Memorandum
Department of Planning & Public Works

To: Planning and Zoning Committee
From: Charlie Campo, Project Planner
Date: 10/120/2008
RE: **P.Z. 28-2007 THF Chesterfield Seven Development (THF Chesterfield Seven Development LLC):** A request for a change of zoning from “NU” Non-Urban District to “PC” Planned Commercial District for a 6.7 acre tract of land located on the north side of Chesterfield Airport Road, one half mile west of the corner of Chesterfield Airport Road and Boone’s Crossing. (17U510028)

Planning Commission Staff Report

Petition: P.Z. 28-2007 THF Chesterfield Seven Development (THF Chesterfield Seven Development LLC)

REZONING PLAN & CROSS SECTION PROFILES

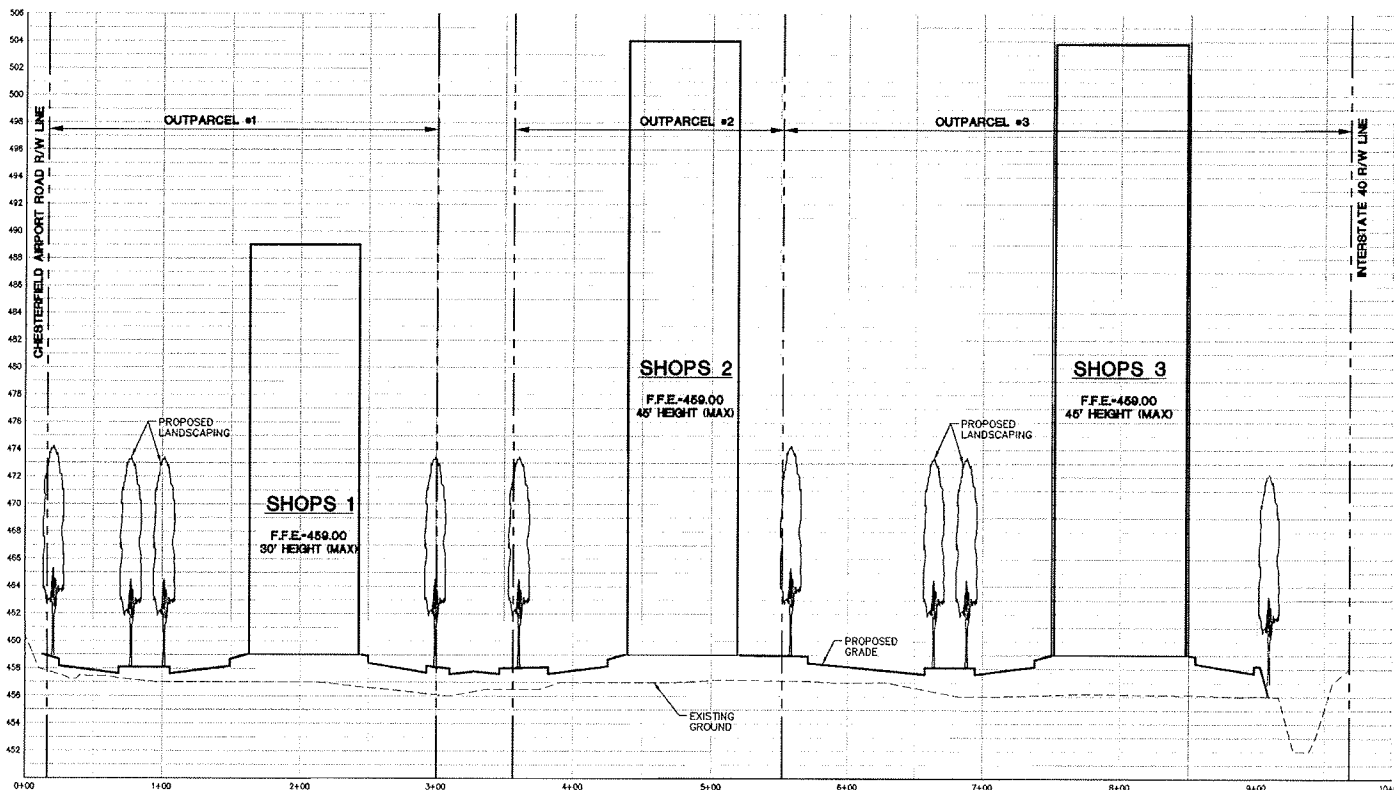
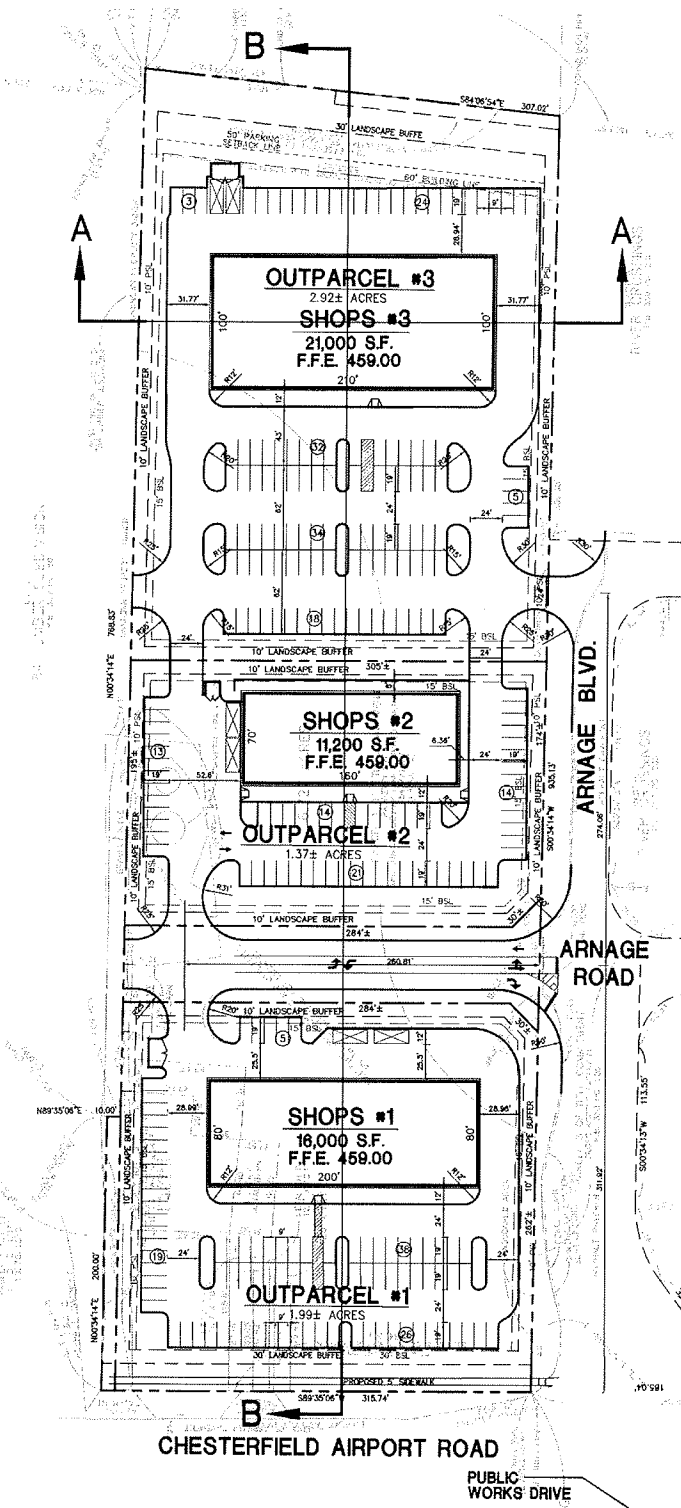
Please be advised, the Department of Public Works has the following comments on the preliminary plan:

- Please be advised that cross access will be required to be provided to 17505 Chesterfield Airport road which is located to the west of this site. The revised plan does not show that cross access can be provided.

- The controlling regulatory 100 year water surface elevation for the site is 456. Any structure within the Supplemental Protection Area must have the lowest floor at an elevation of at least 457. A certification of the actual elevation of the constructed floor will be required prior to occupancy of the building.

- The Chesterfield Valley Storm Water Plan indicates the flow line of the 10 foot flat bottom ditch along the north property line should be 451.32 near the east property line of the site and slope downstream to the west at 0.10%.

Petitioner's response: Petitioner understands from conversations with staff that this requirement has been deleted.

Petitioner's response: Petitioner acknowledges this requirement.

Petitioner's response: Petitioner acknowledges this requirement.
